Re: Buckeye Lake State Park
Dam Embankment and North Shore
Launch Ramp/Picnic Point Improvements
Fairfield and Licking Counties, Ohio
Review of Gardner Spillway Adequacy Report

Per your request, a review has been made of the Buckeye Lake Spillway Adequacy Report prepared by W.S. Gardner and Associates for the Save The Lake Committee. In general, the Probable Maximum Precipitation (PMP) and the Probable Maximum Flood (PMF) pool elevation, for existing spillway conditions with no overtopping of the dam, shown in the Gardner report do not differ significantly from those developed by Dodson-Lindblom Associates, Inc. (DLA) in 1987. However, in reviewing the Gardner report in some detail, several inconsistencies were noted regarding the presented modeling. These inconsistencies include:

HYDROGRAPH AT STATION WALNUT

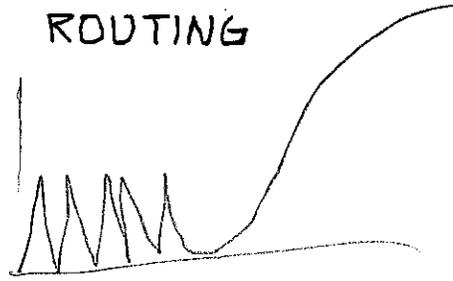
- 1) It appears the rainfall has been distributed over a 12-hour time frame, not a 6-hour period as mentioned in the report. The inflow hydrograph and its resultant peak will be different if the rainfall is based on a 12-hour period rather than a 6-hour period. The Gardner report also states the rainfall distribution corresponds to a type II distribution, which is not apparent based on the model.

12 HRS

MAXIMUM PMF POOL 894.1

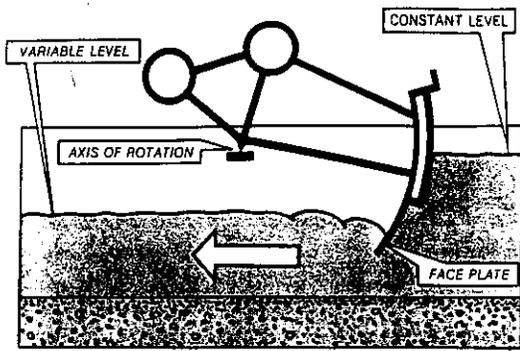
- 3) With 23,000 cfs being released from the lake at a time of minimum inflow to the lake, the result would have to be a significant decrease in the pool level. However, the HEC-1 model presented in the Gardner report does not allow for a decrease in the pool level below elevation 892 (the surface area/elevation data begins at elevation 892). DLA modified the Gardner model to include data below elevation 892. The results indicate the pool level would drop to an elevation below 889 before inflow to the lake exceeded that which was being released and the pool begin to rise. Results also indicate the pool would drop from 891.75 (normal pool) to below 889 in less than 6 hours. This rapid drawdown could have serious impact on the stability of the dam.

Initial outflow \approx 23,000 cfs is greater than inflow (see previous page). Lake should be dropping below elevation 892.0 but input data does not go below 892.0.

AMIL GATE

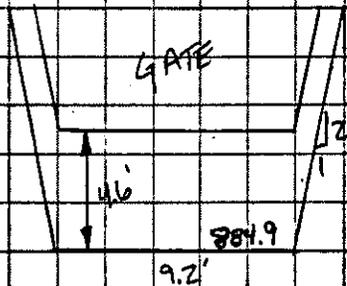
- 4) The Gardner HEC-1 models show an area of 340 square feet for the Amil gates. The actual area for the existing Amil gate, when it is completely open, is approximately 50 square feet below the gate and 90 square feet if the openings around the sides of the gate are included. The Gardner model indicates a peak outflow from the gate of 4500 - 5500 cfs. The peak flow for the existing gate is closer to 600 - 800 cfs. A copy of the Amil gate brochure is attached.

DLA VALUES ARE LOWER TAKING INTO ACCOUNT HEADLOSS
ACROSS WEIR 1/3 OF EXISTING AMIL.
